"PROPOSED OVERALL AREA DEVELOPMENT PLAN"

MISTY OAKS NORTH, UNIT - 1 & 2

RE: Misty Oaks North POADP #88

RE: Misty Oaks North, Units 1&2 POADP
(File #83-11-60-20) (Revised December 11, 1985)

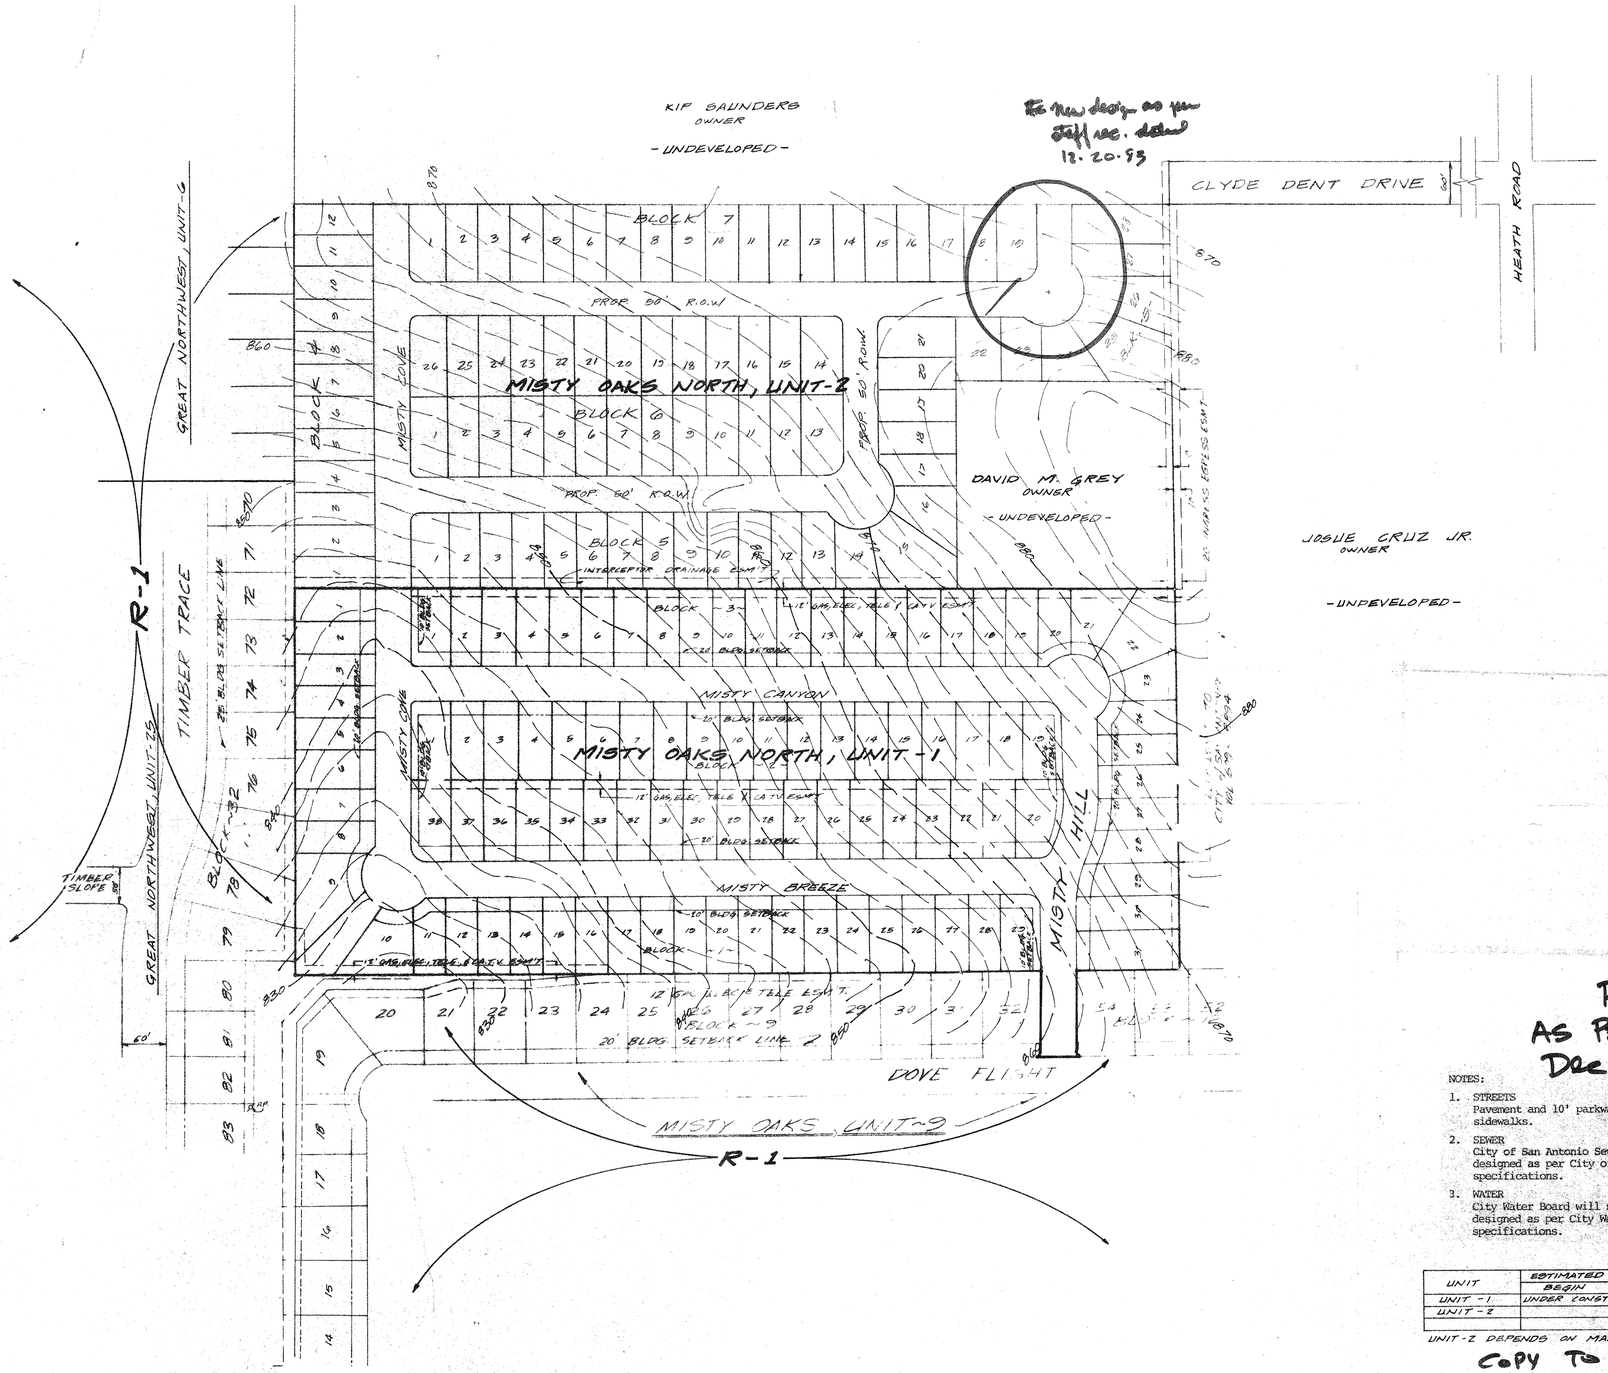
(X) Comments: A street design amendment as generally shown on the attached P.O.A.D.P. is recommended. The proposal would allow a linkage with the potential Clyde Dent extension.

(✓) Comments: ~~Staff rec. that consideration be given to~~ a street design amendment as generally shown on the attached P.O.A.D.P. is recommended. This proposal would allow a linkage with the potential Clyde Dent extension.

P.O.A.D.P. REVISED
AS PER COMMENTS DATED
DEC. 20, 1983
(street design amendment)

(X) Comments: This acknowledges receipt of the street design amendment as suggested by the staff in the POADP review comments dated Dec. 20, 1983. Staff offers no objections to the amendment as submitted.

REVISED: 11/15/85

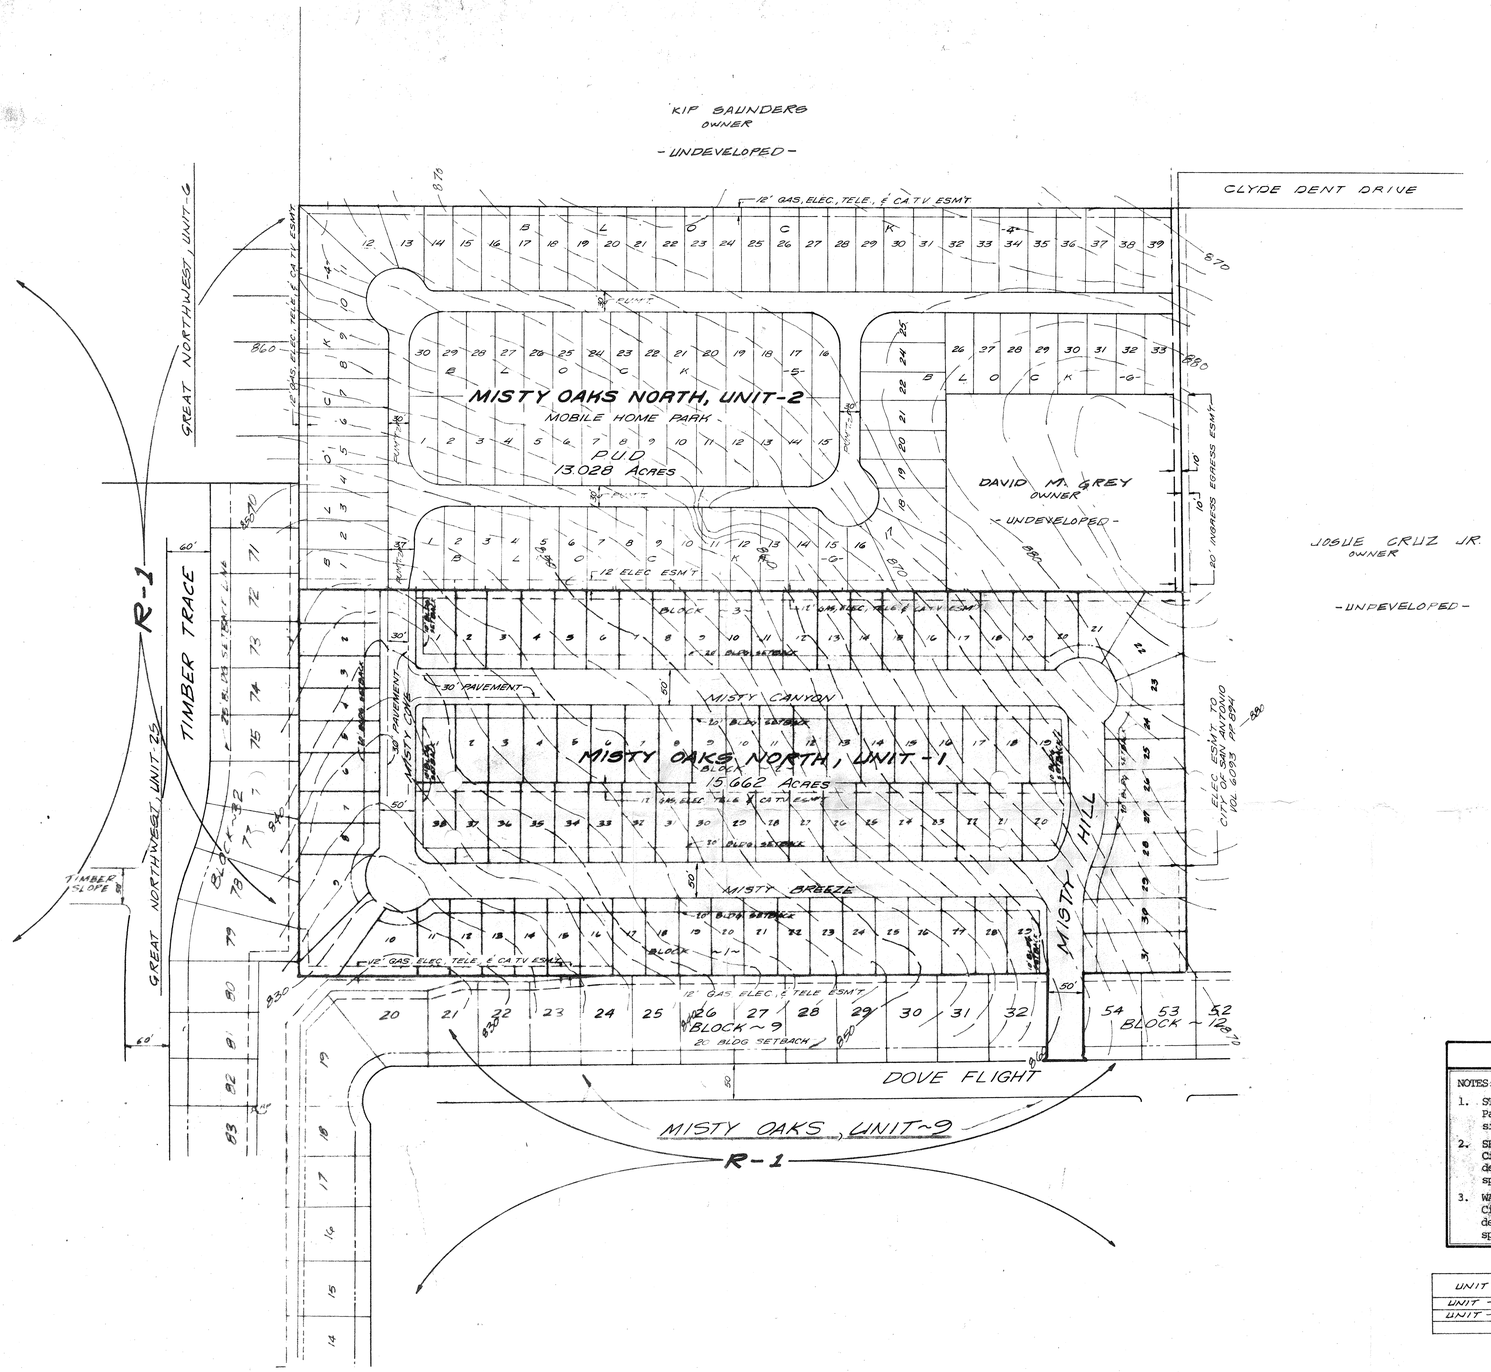
The Committee has two concerns with the revised plan.

1. If Unit-2 is to be developed as a Mobile Home Park, then access should not be through an established single family subdivision. Access should be gained from Clyde Dent Drive.

2. If the streets in Unit-2 are to be private, then a turnaround should be provided at the end of the public right-of-way on Misty Cove.

REVISED: 12/10/85
11/15/85

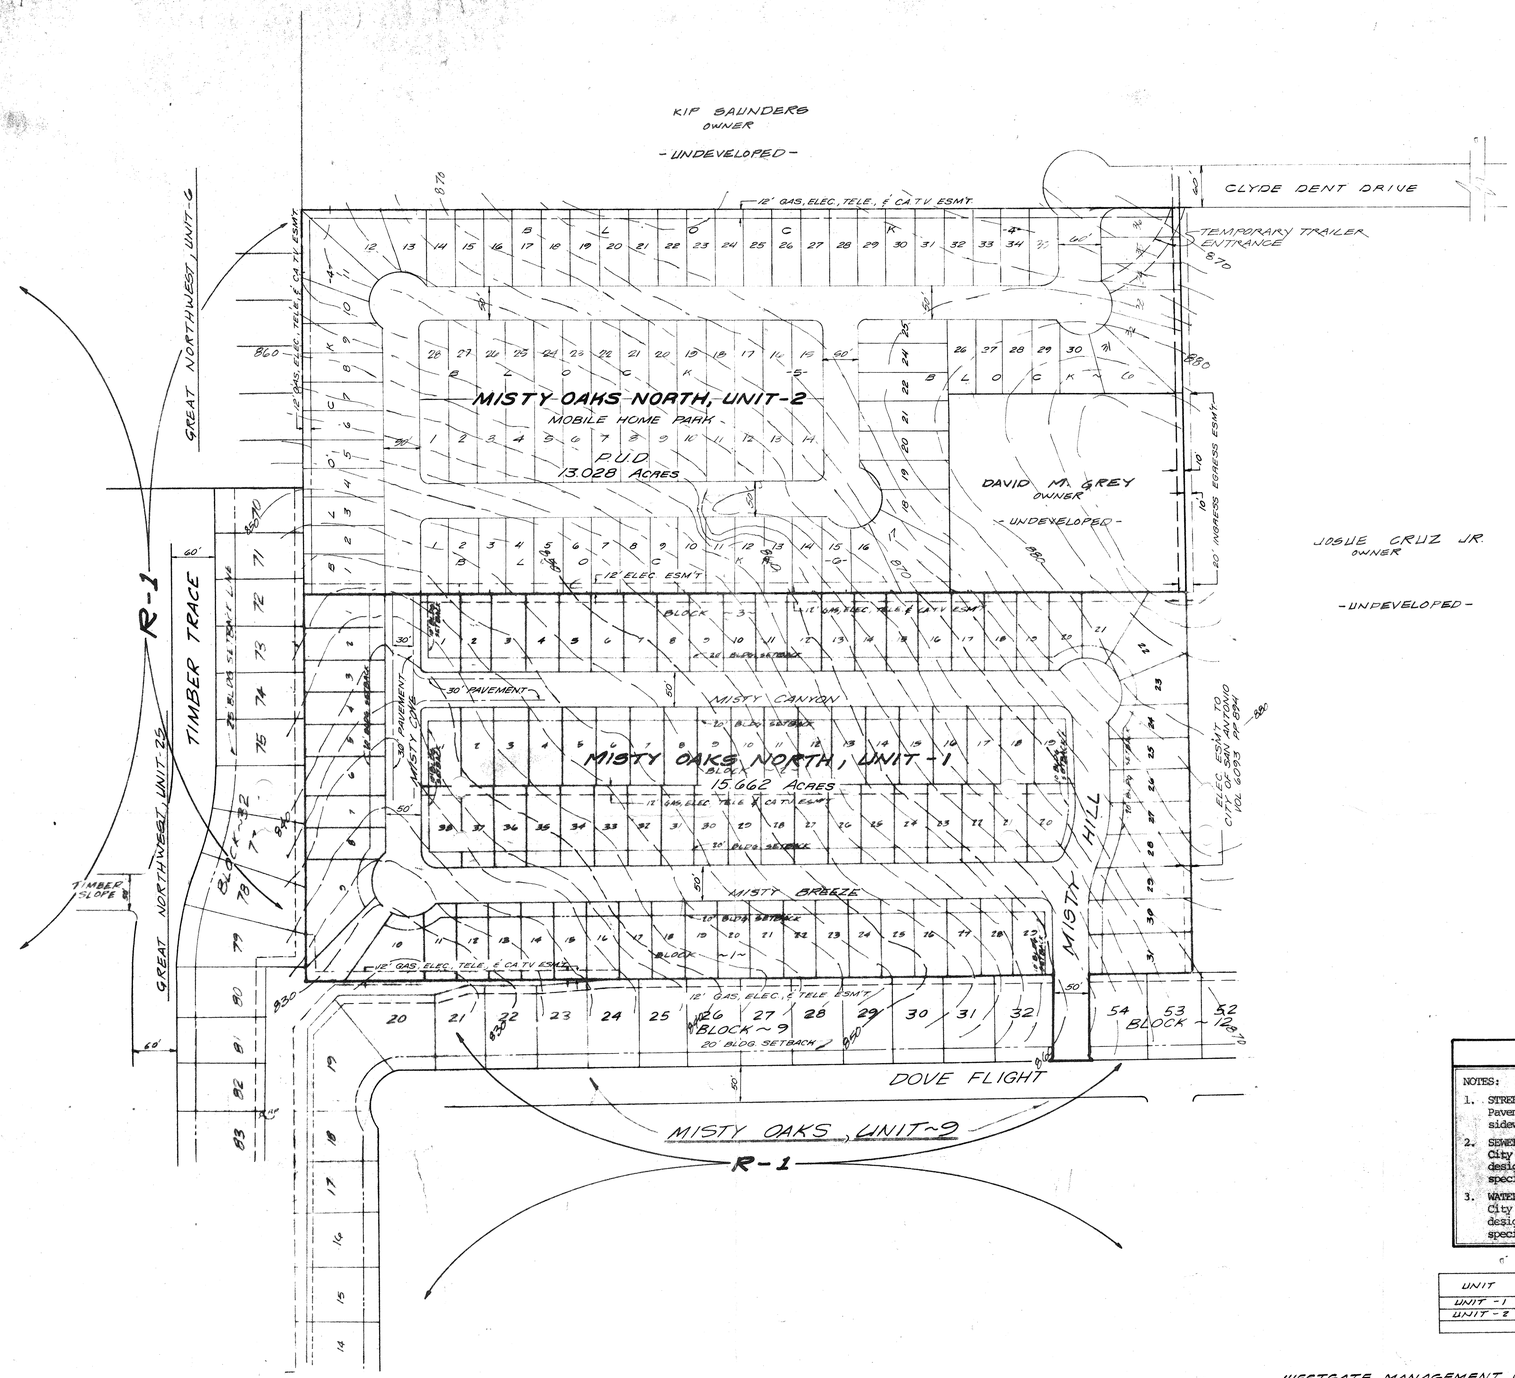
The POADP Committee has reviewed and accepted your proposed plan for Misty Oaks North, Units 1&2 (see attached).

12/10/85
REVISED: 11/15/85
11-08-88

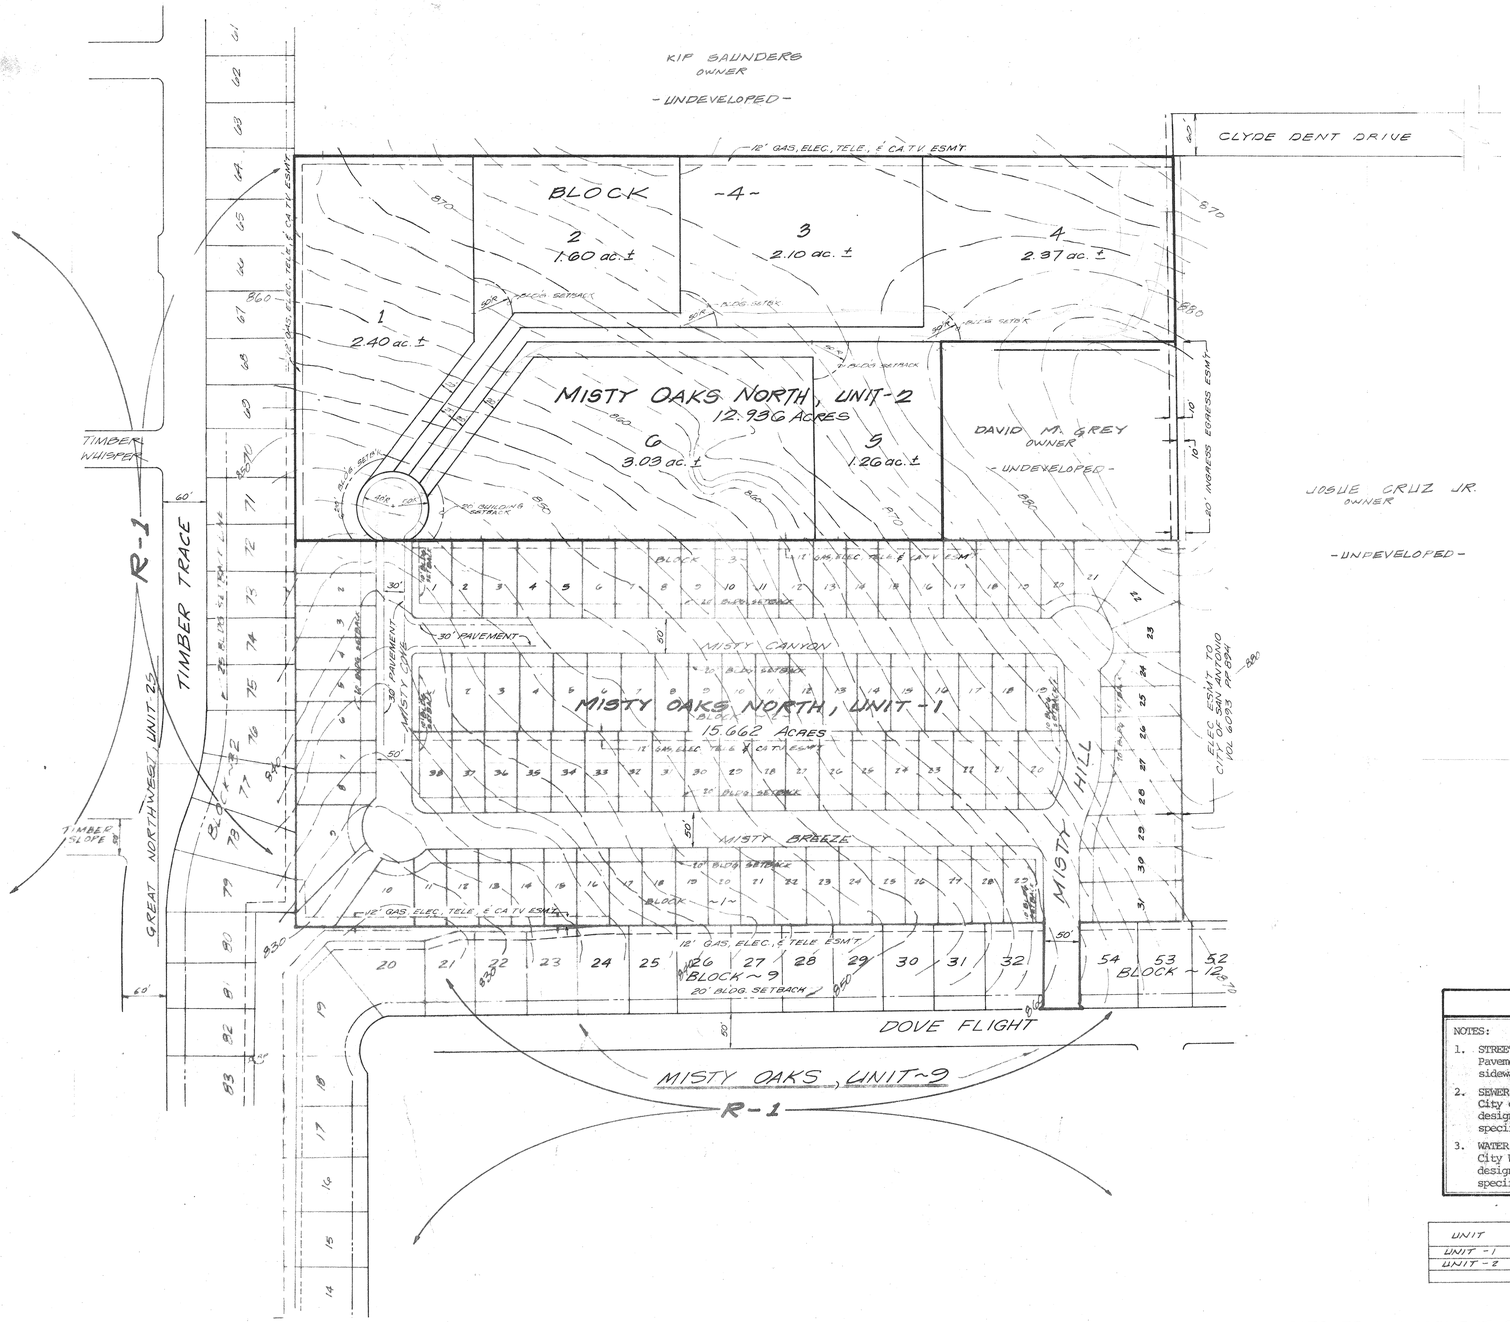
The Development Review Committee has reviewed your revised Preliminary Area Development Plan (POADP) for Misty Oaks #88 on November 18, 1988 and did not accept the plan. The committee requests that Misty Cove Drive be extended to the north property line as a stub street to allow an eventual tie into Clyde Dent. This will provide a second means of access for all the residences north of Dove Flight. In addition, if the large lots should be developed in the future for multifamily or non-residential uses, it would provide an alternative access other than through the single-family subdivision.

The committee ~~recommends~~ requests that Misty Cove Dr. be extended ~~south~~ north to the ~~Kay Saunders~~ property line as a stub street to allow an eventual tie into Clyde Dent. *

* This will provide an a second means ~~point~~ access for all the residences north of Dove Flight. In addition, if the large lots should be developed in the future ~~for non-single~~ multi-family or non-residential uses, it would provide an ~~means to~~ alternative access other than through the single-family subdivision.

Staff's concern is accessibility of emergency vehicles to the immediate area. The plan as designed would require emergency vehicles to gain access through a local street system from Grissom Road which is approximately 2/3 miles from this site. The original POADP and the first revision both provided for a connection to Clyde Dent. However, this second revision does not.

Staff request that this item be withdrawn from consideration. The applicant has submitted an alternative plan which is satisfactory to both the applicant and Planning staff. The applicant is now proposing to prepare a P.U.D. with a pvt. street system. The PUD plan and plat will need to be reviewed and processed in accordance with the Unified Development Code prior to presentation to the P.C.

PLANNED UNIT DEVELOPMENT PLAN "FINAL"

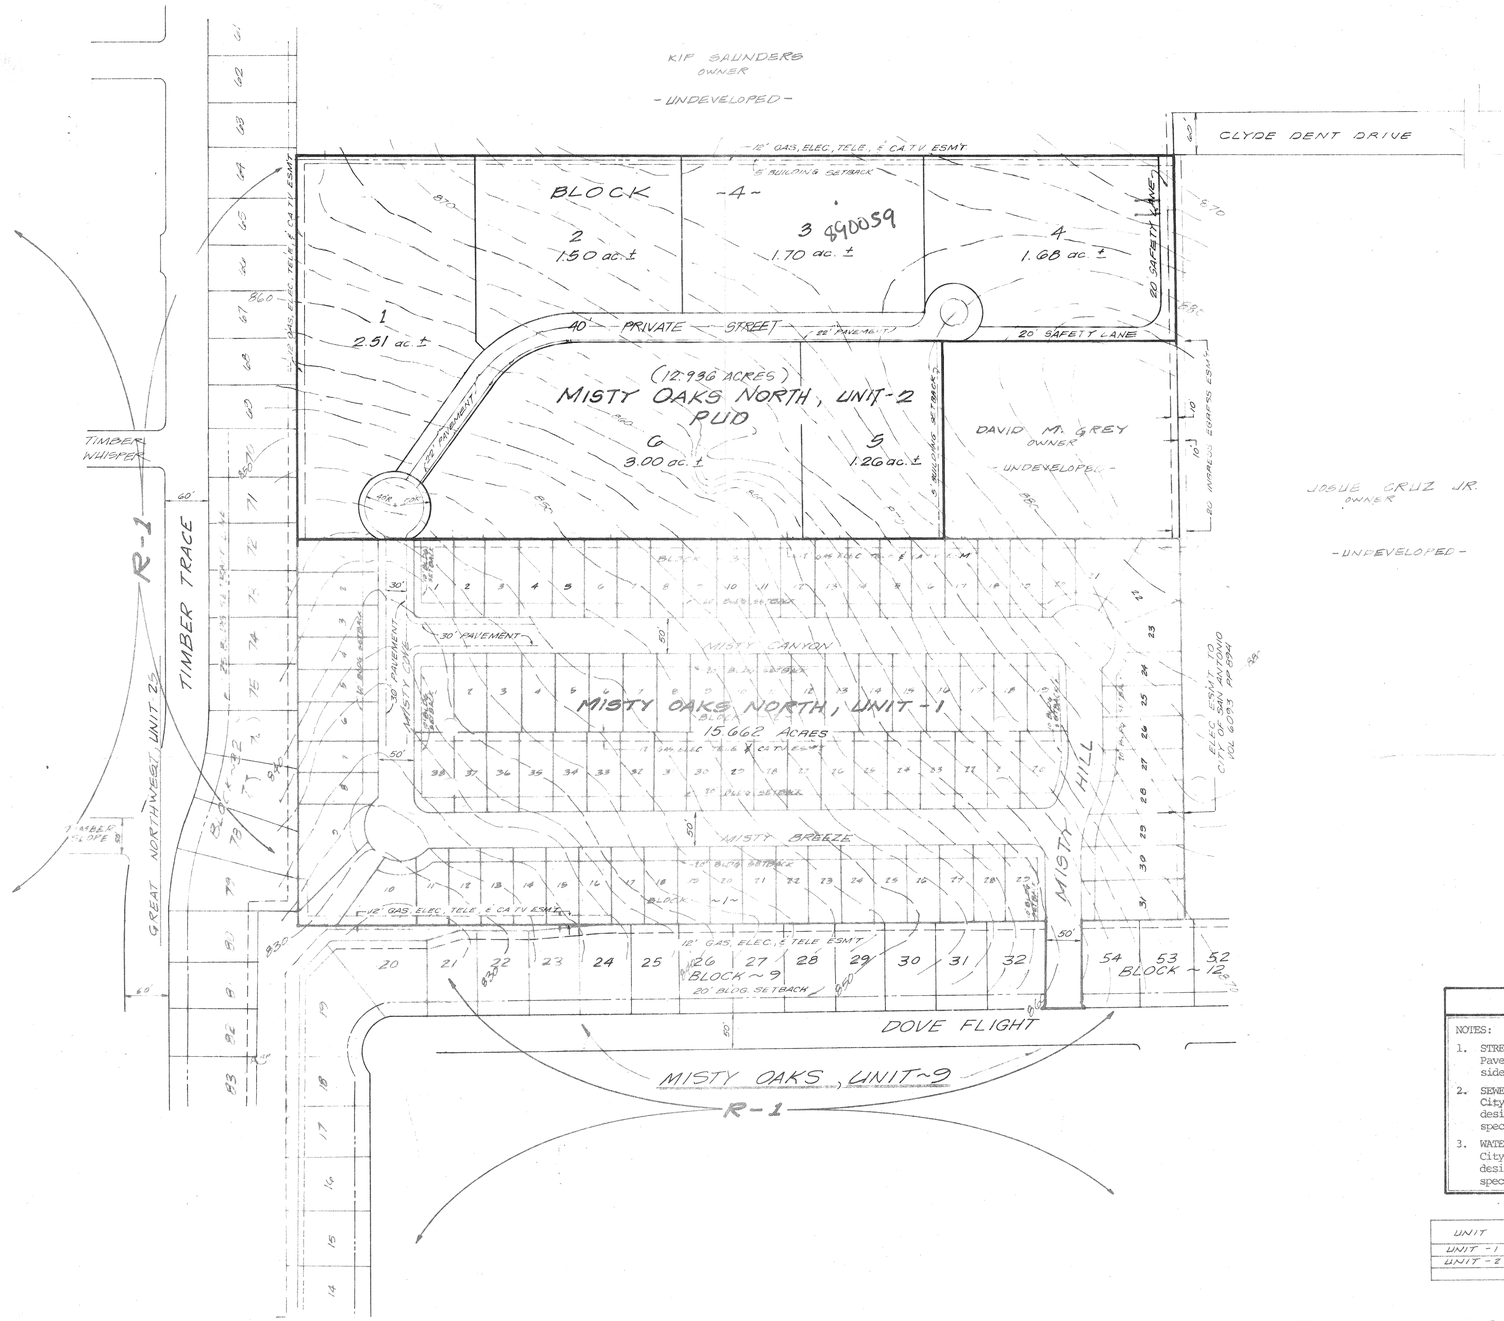
The Development Review Committee has reviewed and accepted the revised conceptual plan for Misty Oaks PUD. Although the committee has accepted the plan as designed, it is still subject to PUD requirements and will need Planning Commission approval. The plan has been assigned File #88 for future reference.
